ADDENDUM NO. 05

Northland Corridor Redevelopment Project Phase 4
631 Northland Ave.
Buffalo, NY 14211

Project No. 432607

Project Northland Corridor Redevelopment Phase 4 (BUDC) Addendum No. 5
631 Northland Avenue, Buffalo, NY Contract -
Wendel Project No. 432607 Date 11/07/2025

A151A

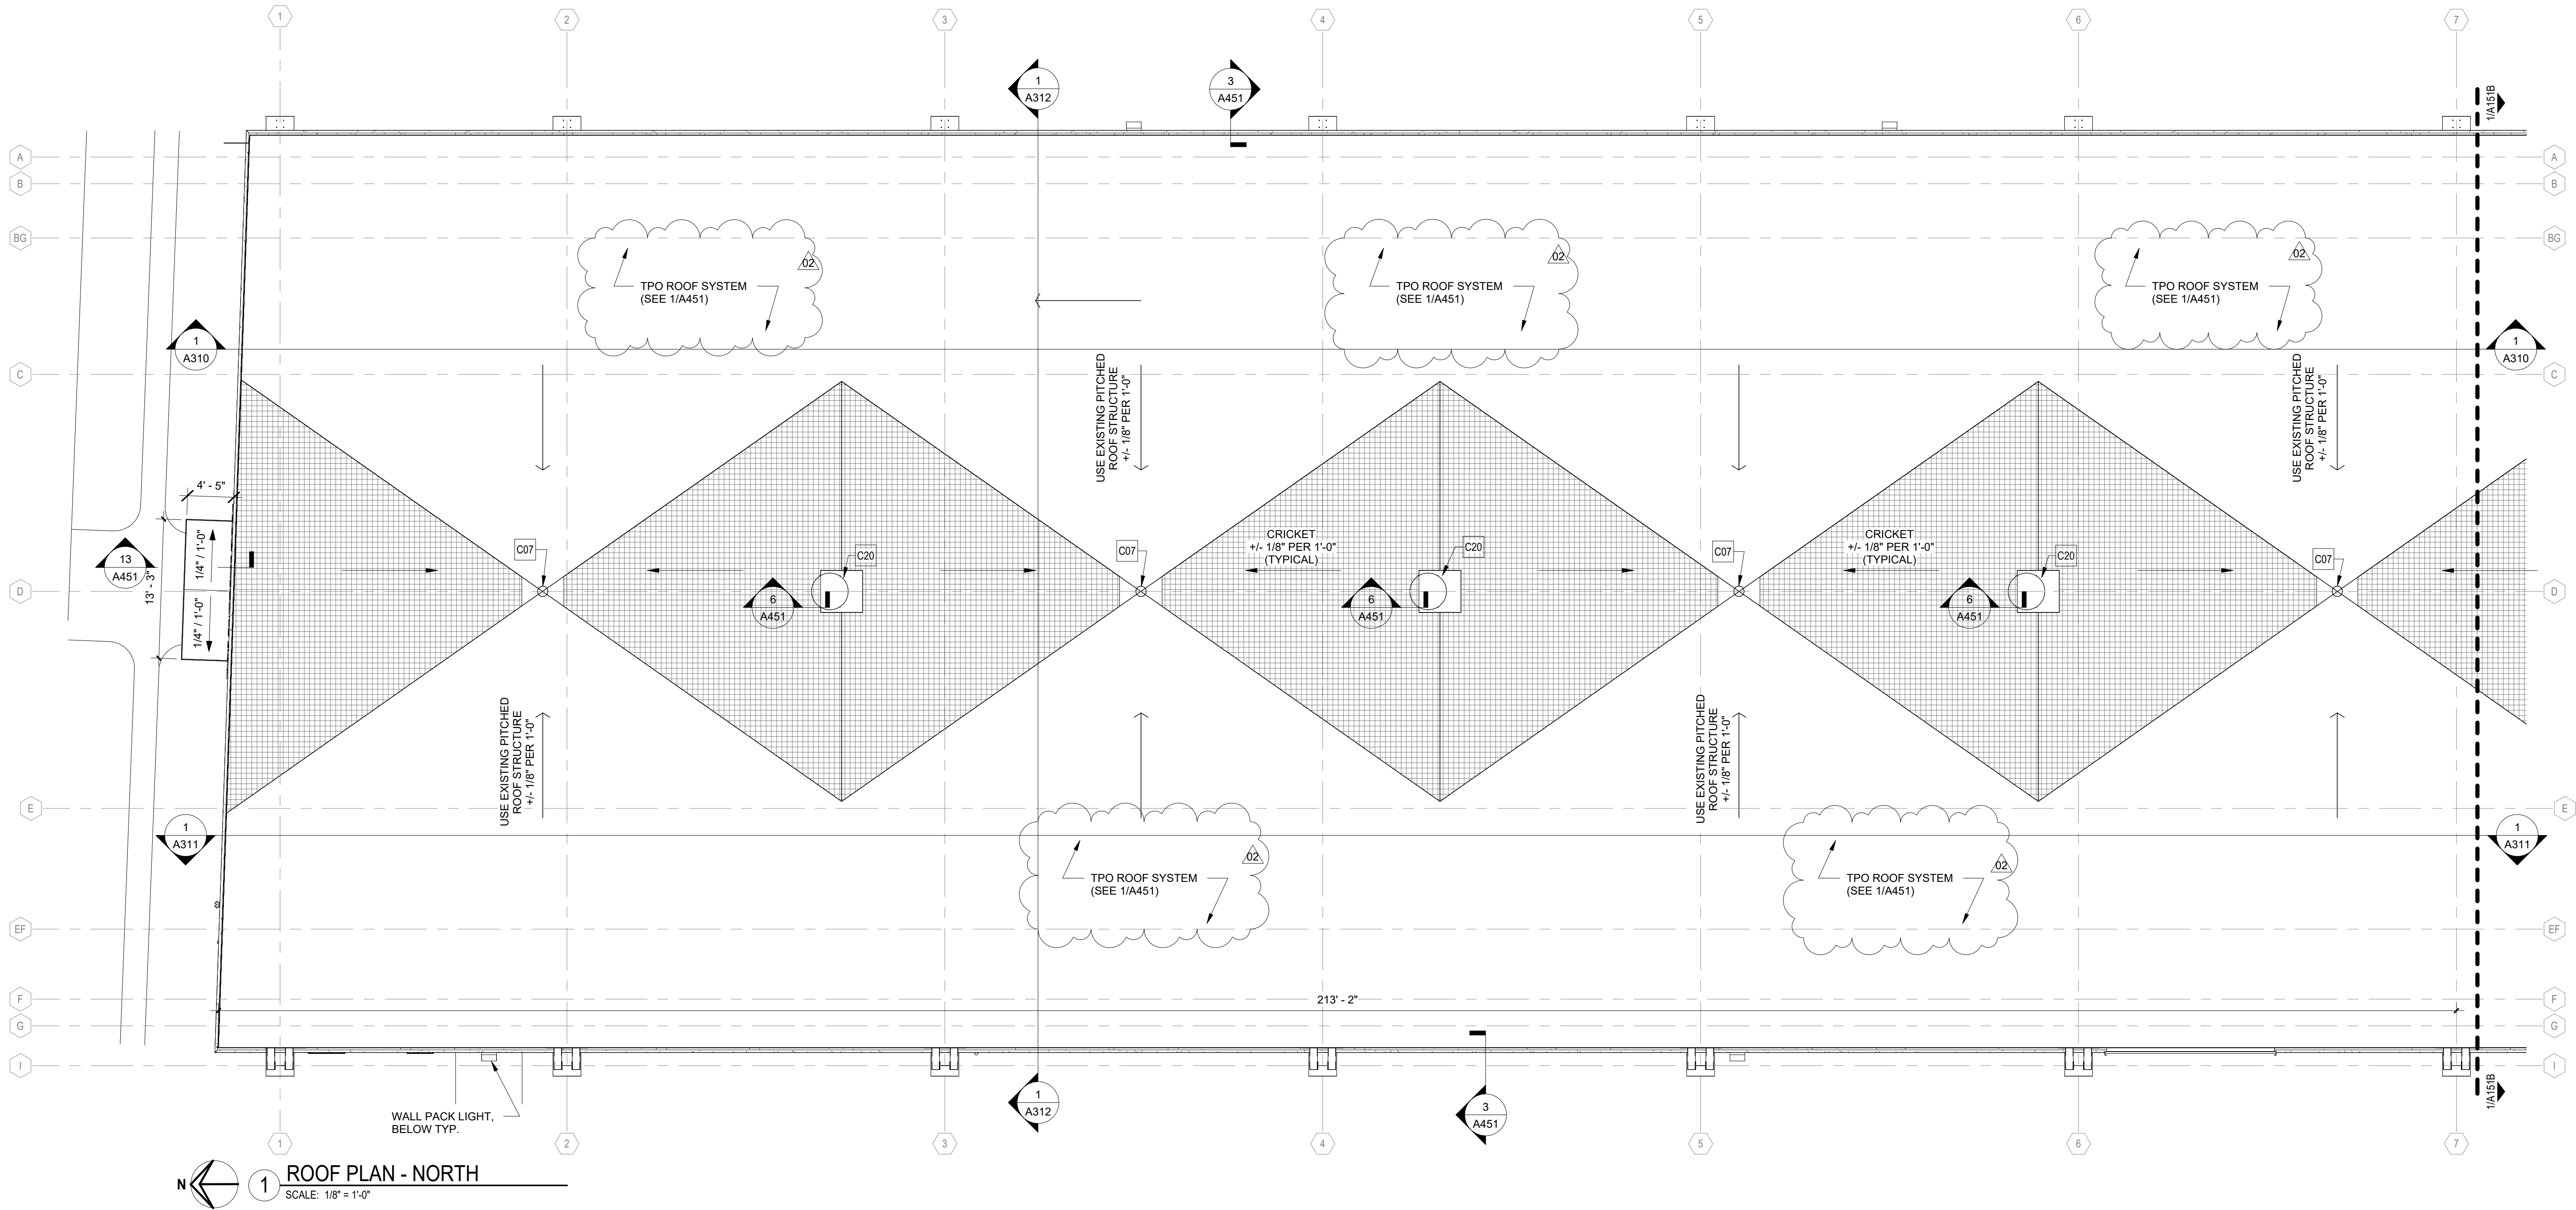
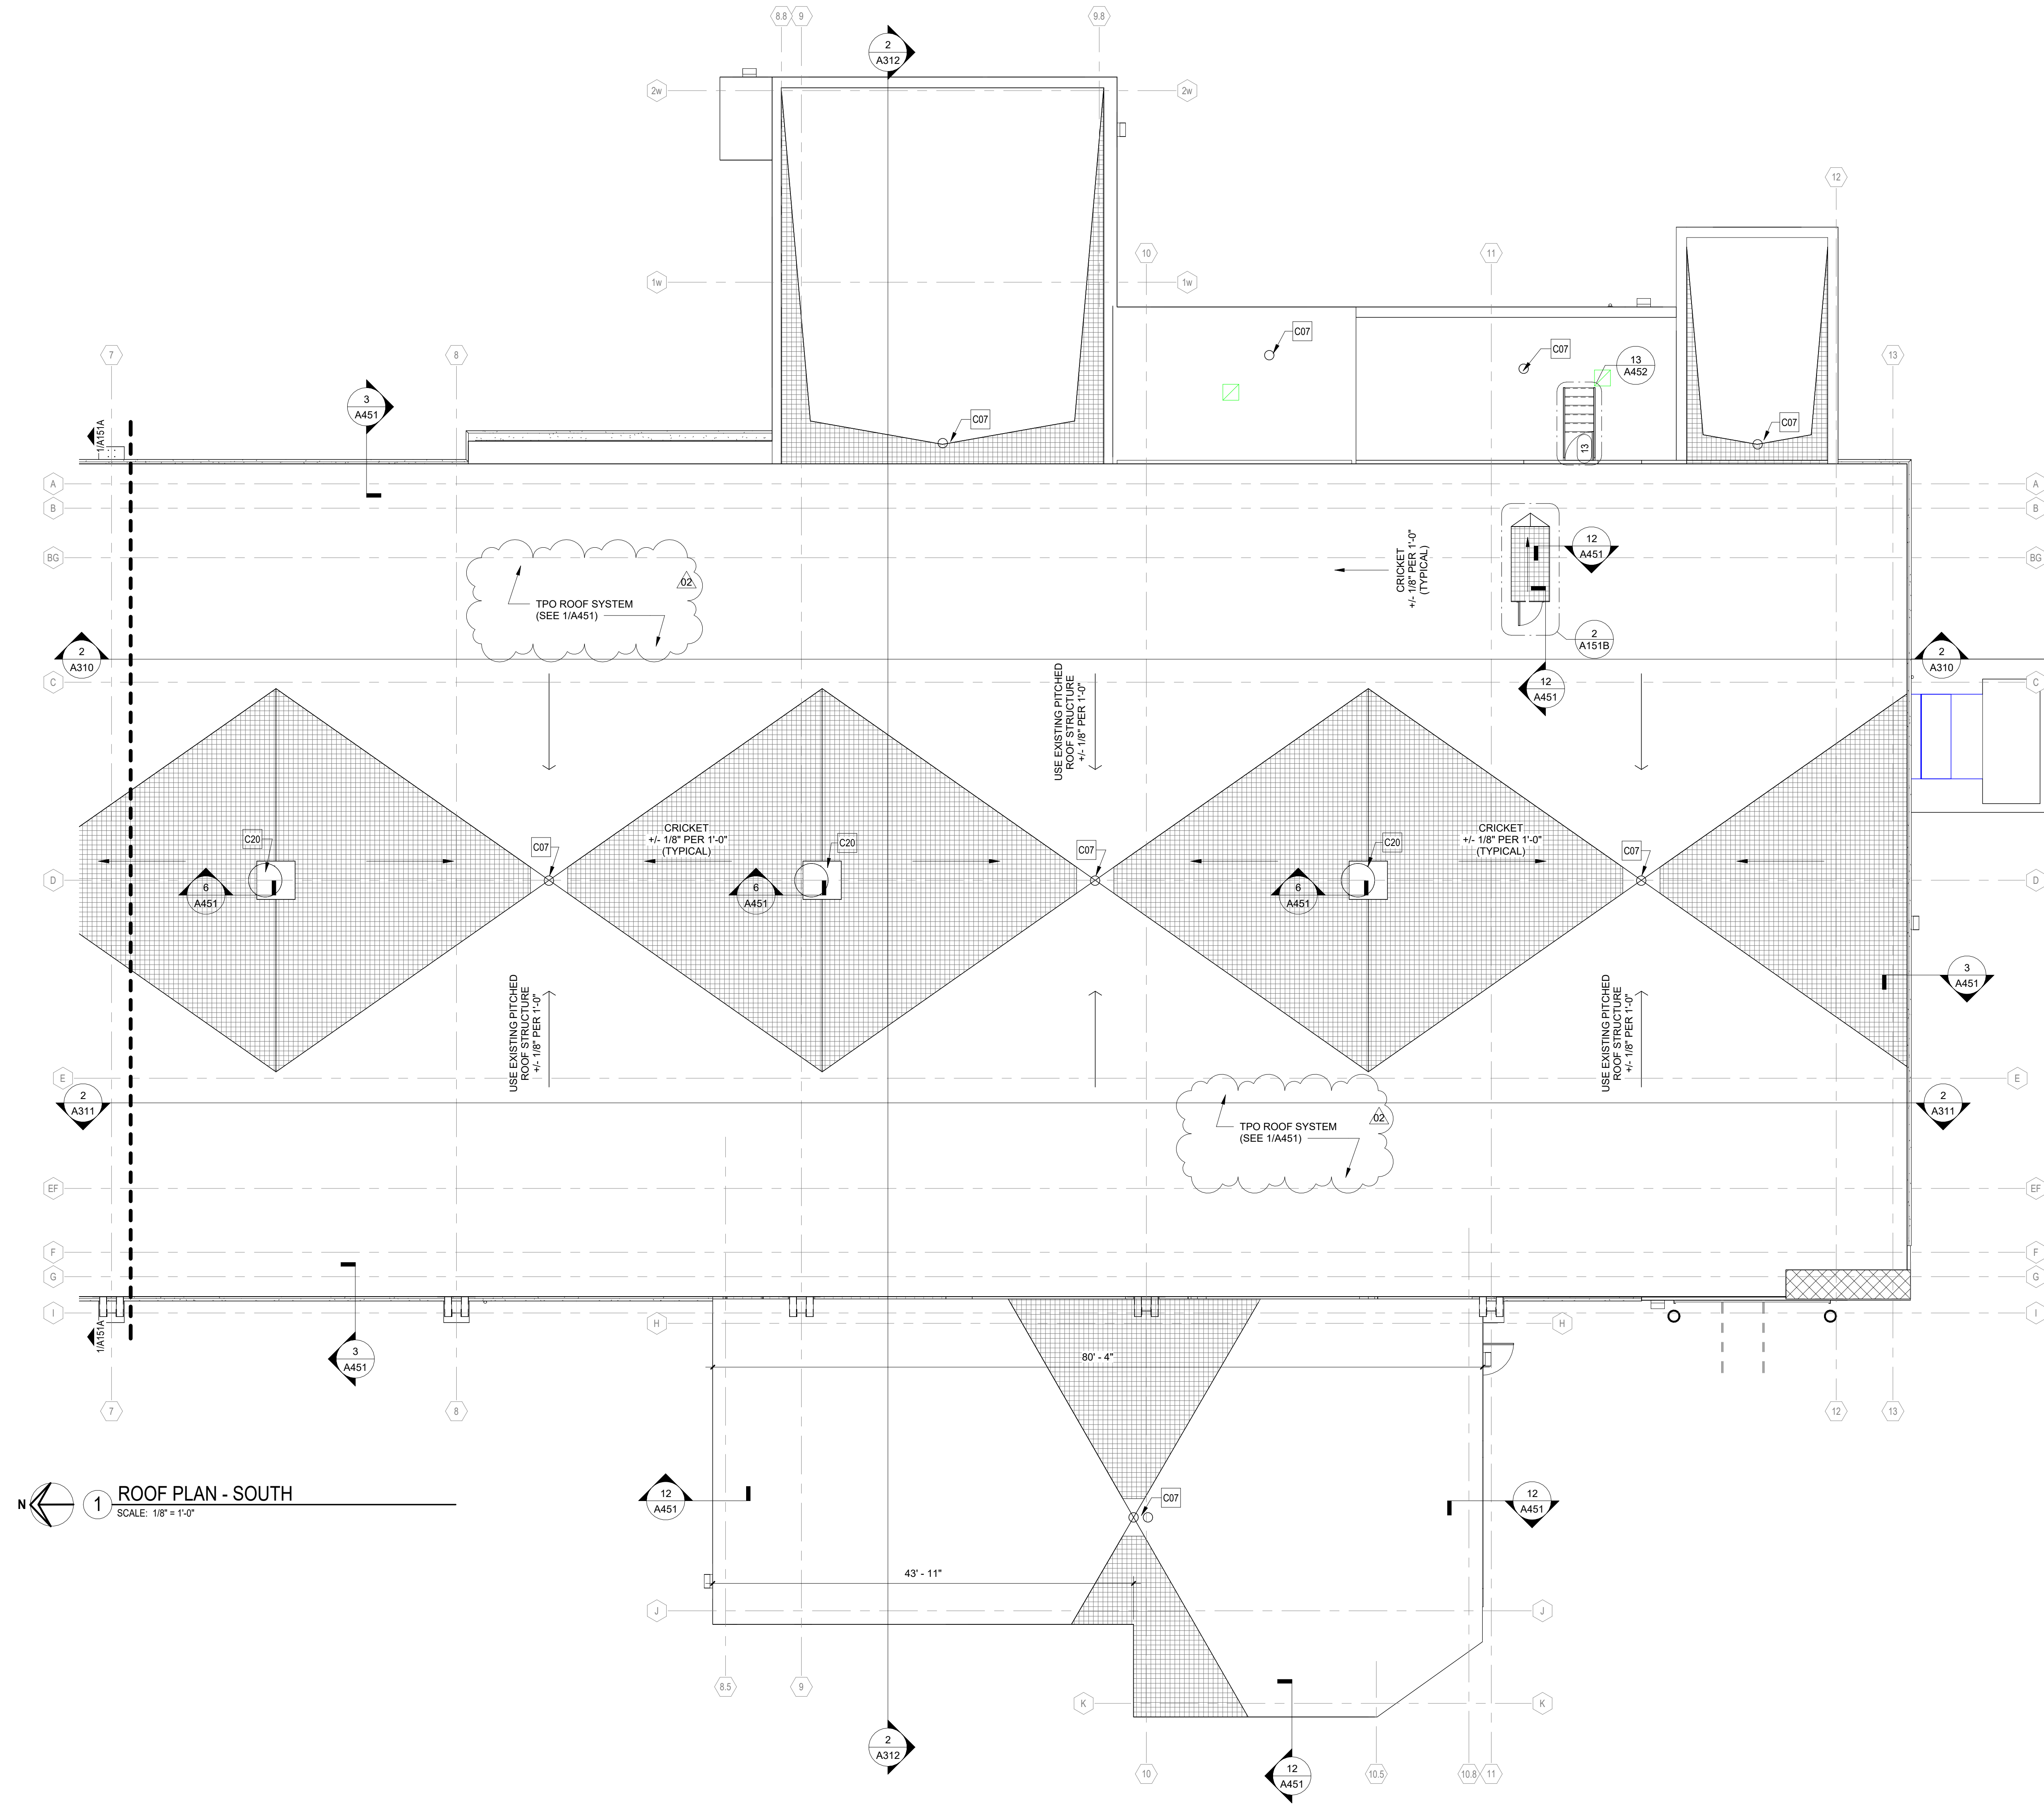
Drawings A151A and A151B reference "New TPO Roof System (see A306)" however drawing A306 is not found in the bid documents received. Where can this drawing be found.

REPLACE: Drawings A151A and A151B with the revised issued as part of this addendum.
